Docket Number:	79-AFC-01C
Project Title:	Compliance - Application for Certification for PG&E Geysers Unit 17 (78-NOI-3)
TN #:	214117
Document Title:	Petition For Staff Approved Project Modification
Description:	Petition for a staff approved project modification to install a steam turbine bypass
Filer:	Bruce Boyer
Organization:	California Energy Commission
Submitter Role:	Commission Staff
Submission Date:	10/20/2016 1:46:51 PM
Docketed Date:	10/20/2016

RE: Geysers Power Company Lake View (Unit 17) Geothermal Project: 79-AFC-01C
Turbine Bypass Project

GEYSERS POWER COMPANY, LLC
LAKE VIEW (UNIT 17) GEOTHERMAL POWER PLANT
PETITION FOR A STAFF APPROVED MODIFICATION

Lake View (Unit 17) Turbine Piping Arrangement:

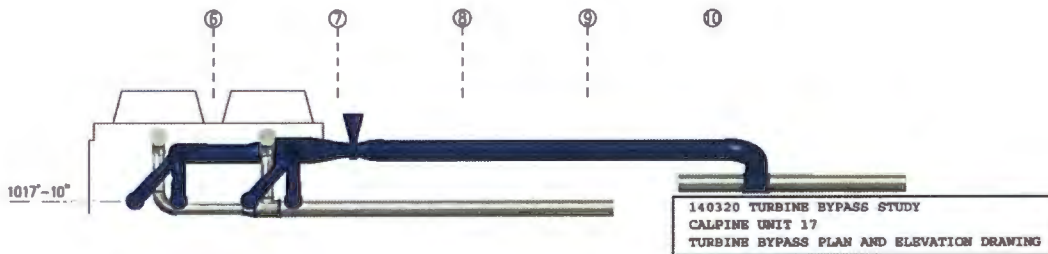
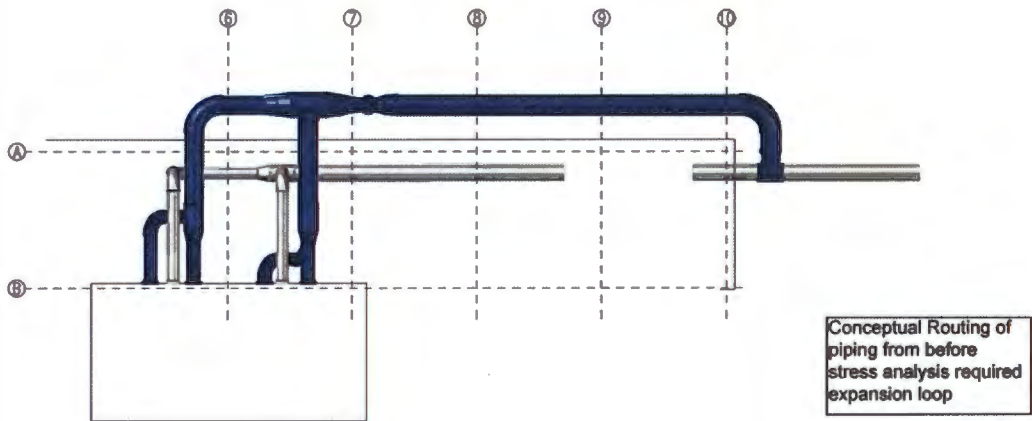
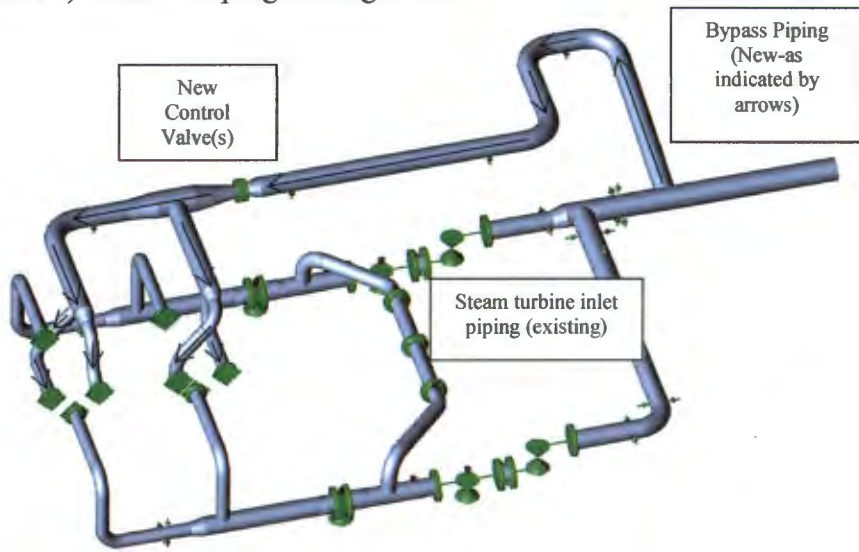
The steam turbine bypass at Lake View will consist of approximately 350 feet of steam pipe that will be connected to a tee on the inlet steam piping upstream of the steam turbine control and stop valves. The steam flow rate will be controlled by control valves with manual block valves on each side. For good distribution of steam in the condenser, connections will be made into the condenser and distributed inside with separate manifolds going across the width of the condenser. The distribution and number of these entries will be optimized to achieve optimal performance. Water spray headers may also be used with the steam manifolds to cool the bypassed steam as it enters the condenser if necessary. The maximum steam design flow of the turbine bypass at Lake View will be 1.2 million pounds per hour.

The installation of the turbine bypass system will take place in or just outside the turbine building and will not be noticeable to nearby residents. No off site staging areas will be required and the installation will be conducted by a small crew of contract workers anticipated to be at most 4-8 people for 6-8 weeks for the mechanical installation, including prefabrication. The electrical and controls portion would involve a couple of electricians for 3 weeks, followed by a couple of weeks for controls development and trouble shooting. Materials for the Project can be transported by several trucks and there will be no notable increase in truck traffic over that which normally supports Geysers routine plant and field work. A few minor supports will need to be augered within the existing plant yard for steam line supports as well as work access platforms to allow servicing of control valves.
